**IEEE Std 80™-2000**(Revision of  
IEEE Std 80-1986)

# Errata to IEEE Guide for Safety in AC Substation Grounding

**IEEE Power Engineering Society***Correction Sheet***Issued 21 February 2007**

Figure 12—Basic shock situations

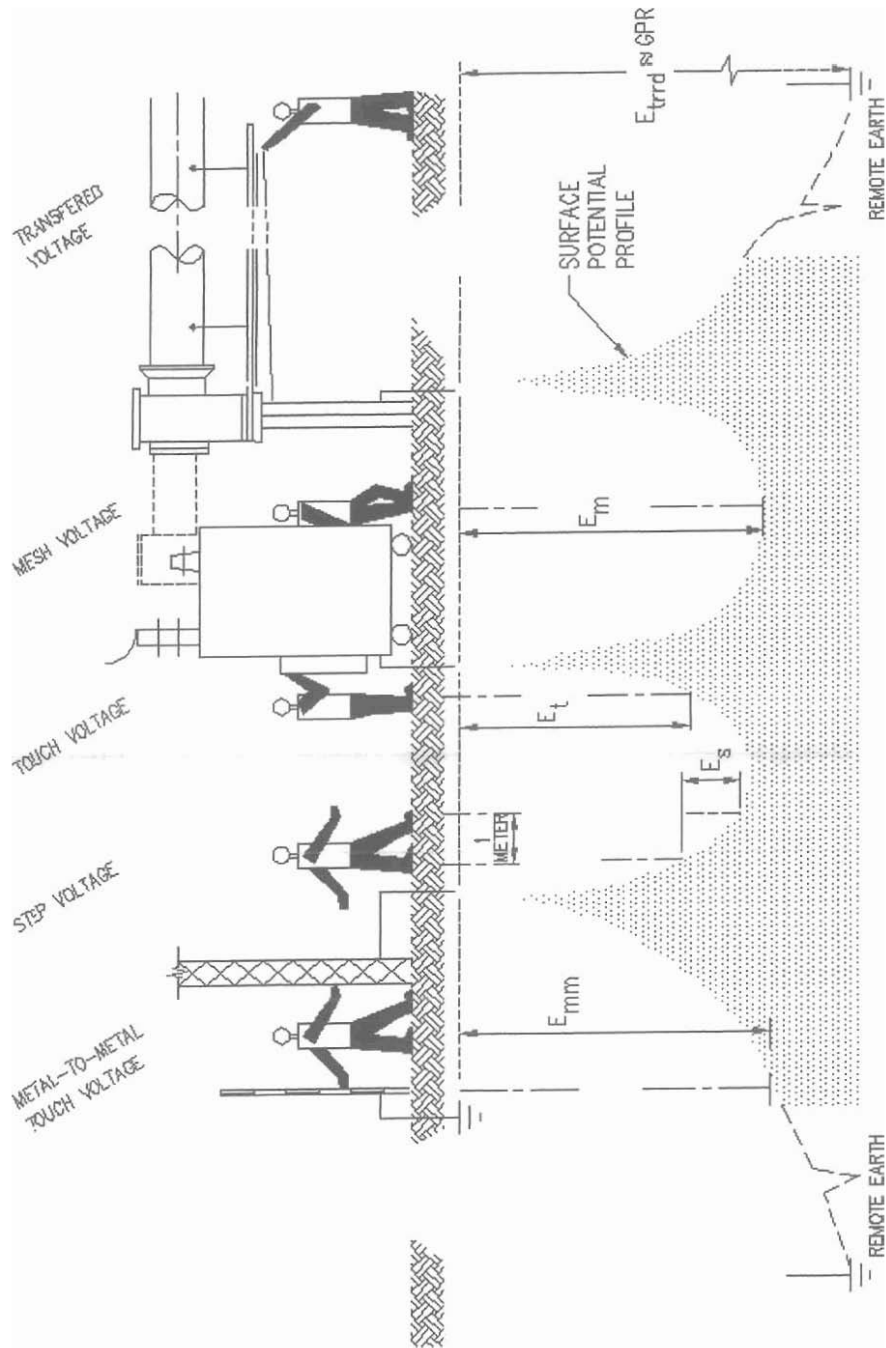
Page 24, Figure 12—Basic shock situations, should be replaced with the following figure:
